CHICK-FIL-A

Kokomo FSU

4
 ENTIRE SHEET REVISED.
 - GAS DELIVERY PRESSURE REVISED TO 2PSI.
 - GAS PIPE SIZES REVISED PER CHANGE TO GAS DELIVERY PRESSURE.
 - STEP DOWN REGULATORS ADDED.
 - KEYNOTES REVISED.

FSR#05681
BUILDING TYPE / SIZE: P14 SE BN
RELEASE: 24.05
PRINTED FOR: CONSTRUCTION
REVISION SCHEDULE
NO. DATE DESCRIPTION
4 07/22/2025 GAS

2 ORDER CANOPY GAS PIPING ISOMETRIC

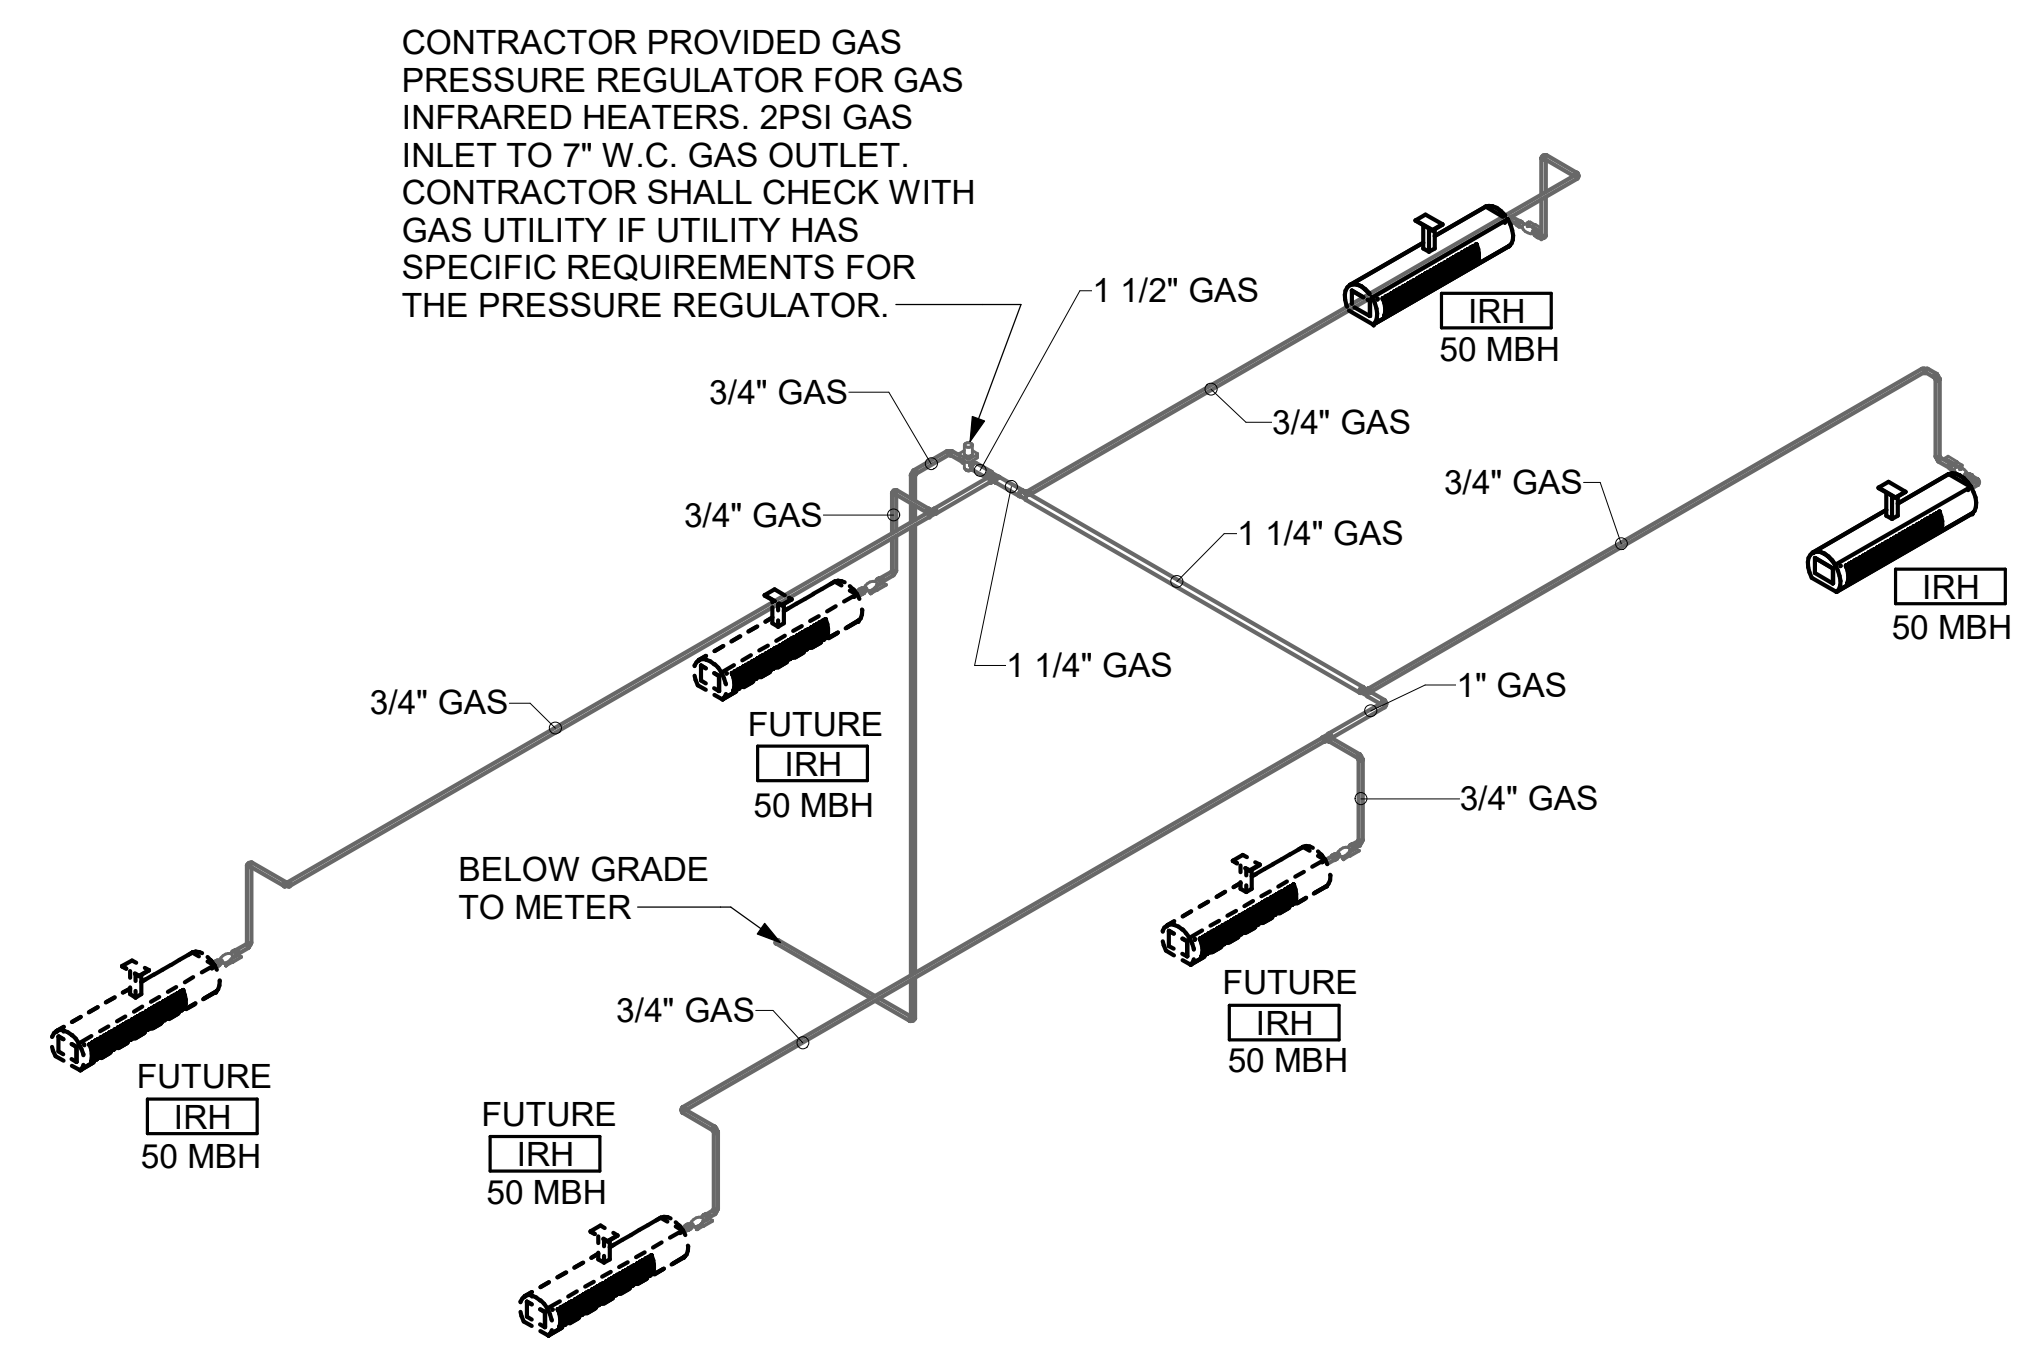
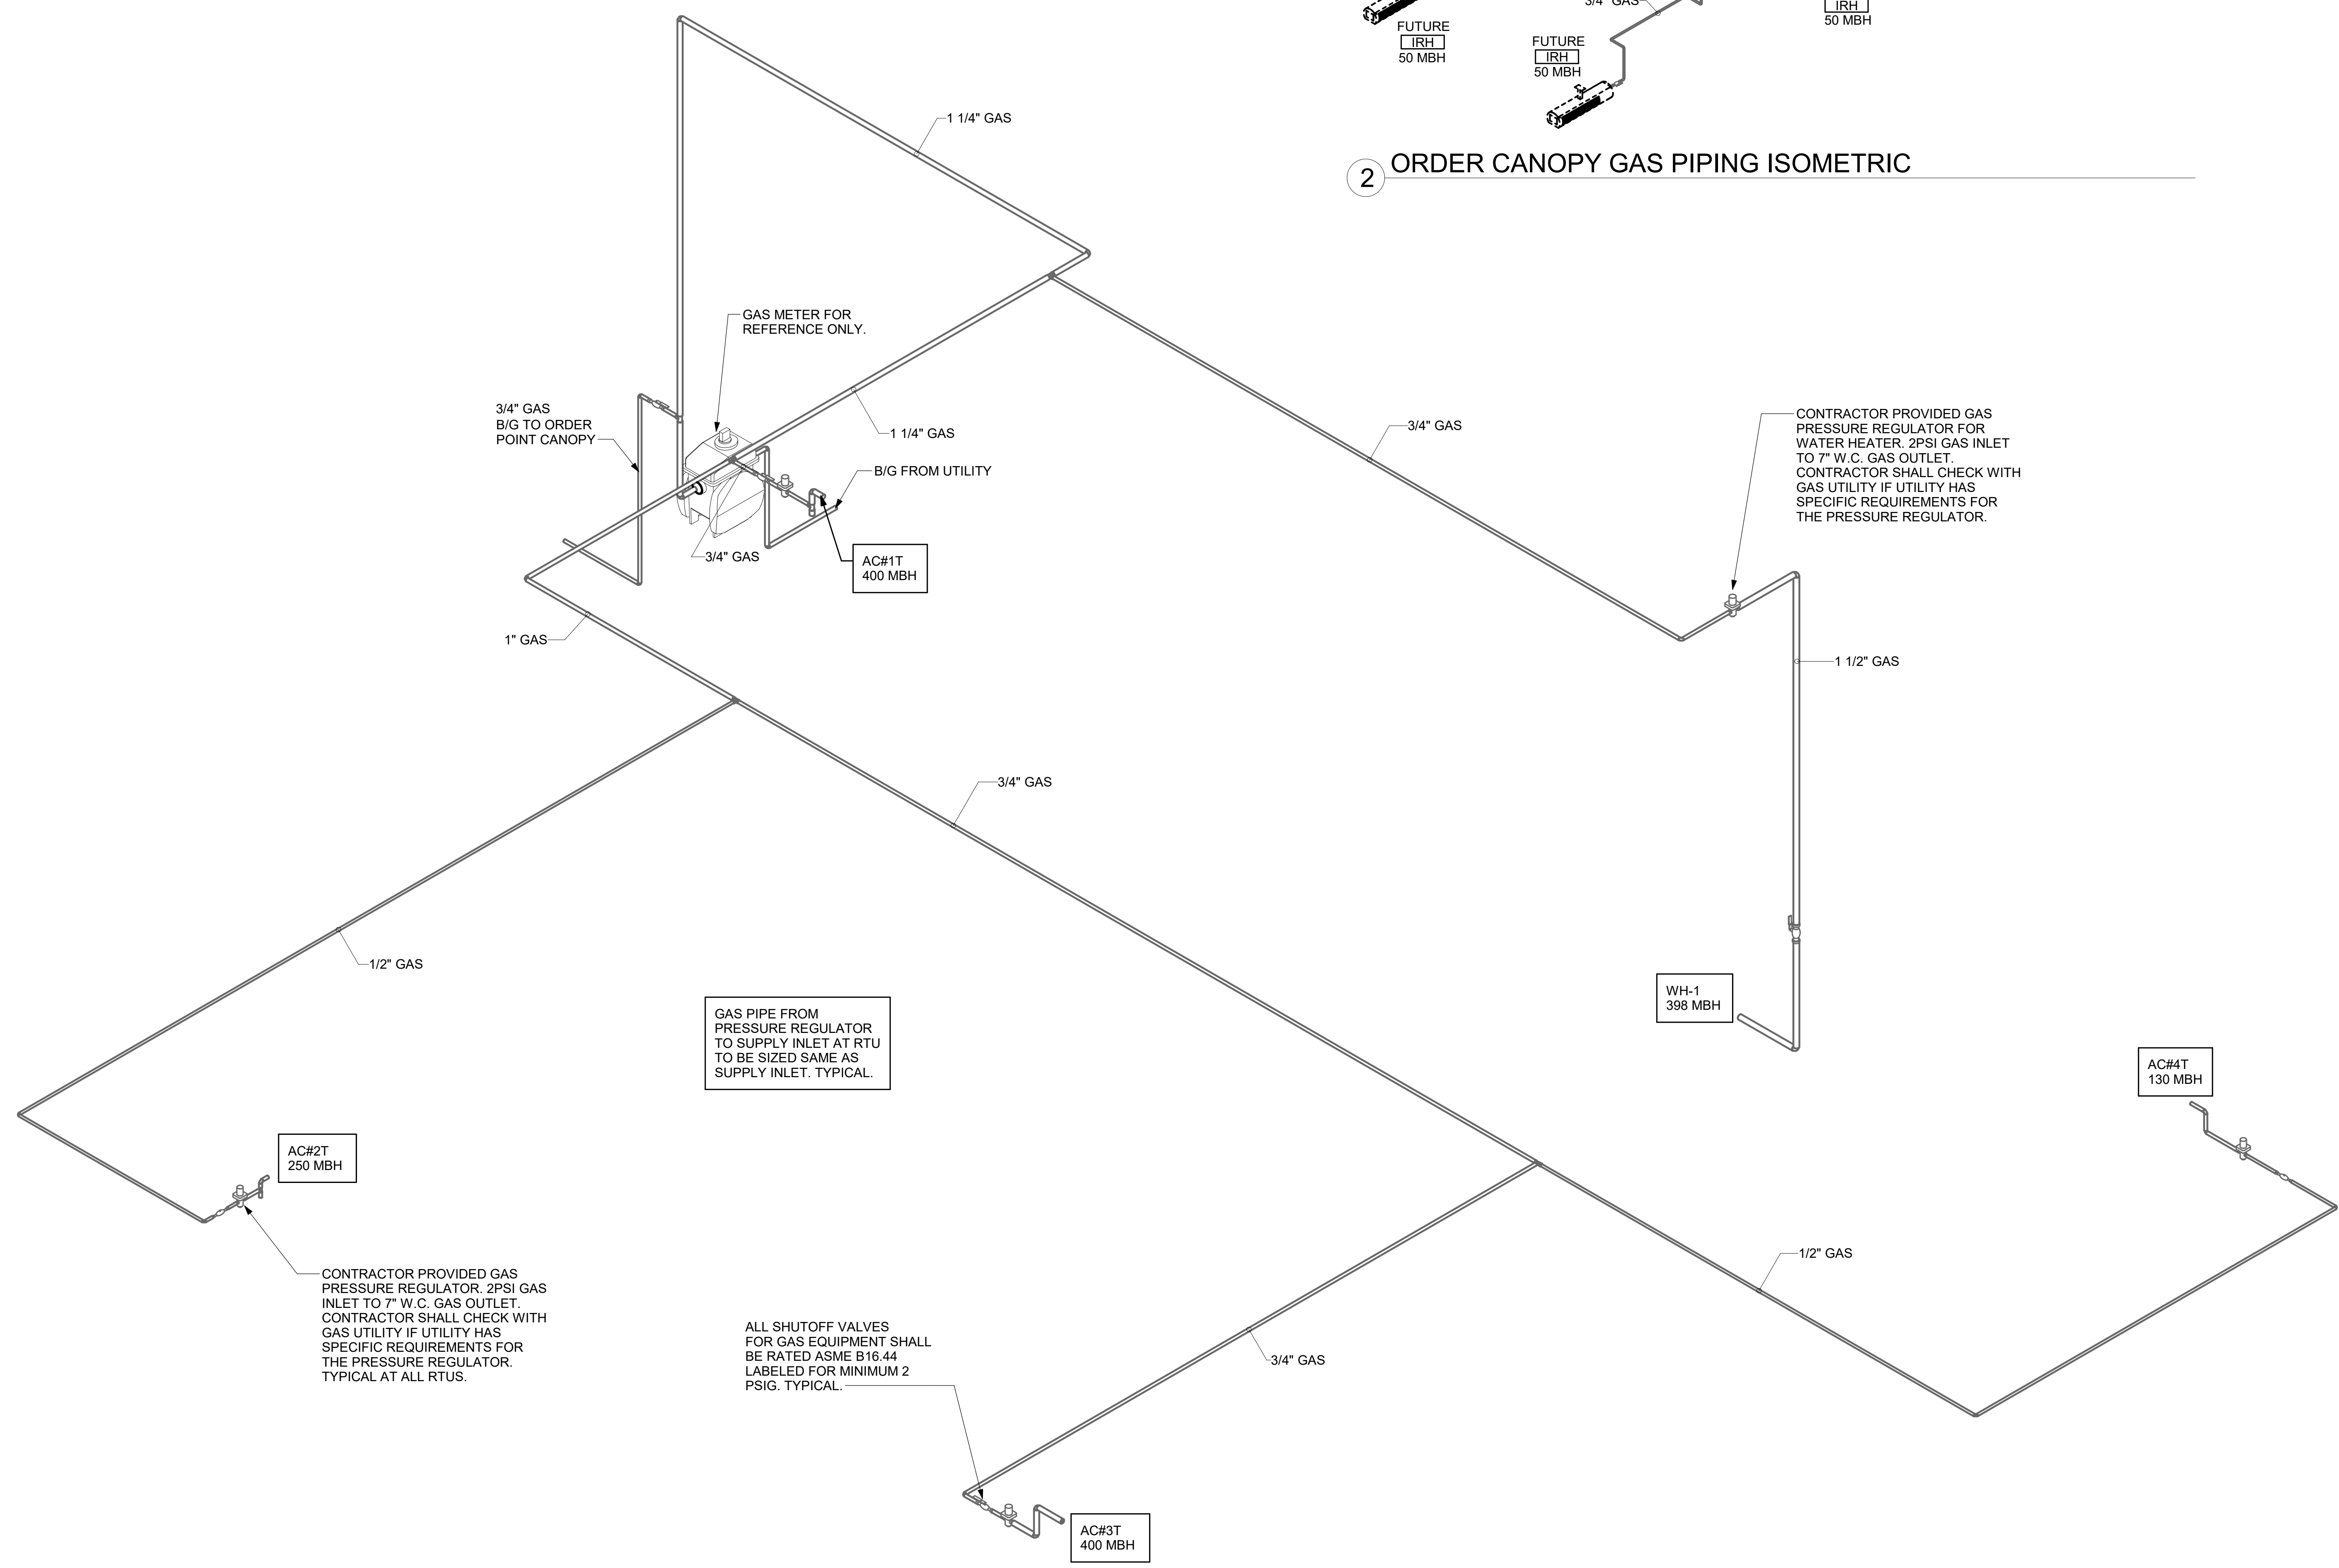
ENTIRE SHEET REVISED.
 - GAS DELIVERY PRESSURE REVISED TO 2PSI.
 - GAS PIPE SIZES REVISED PER CHANGE TO GAS DELIVERY PRESSURE.
 - STEP DOWN REGULATORS ADDED.
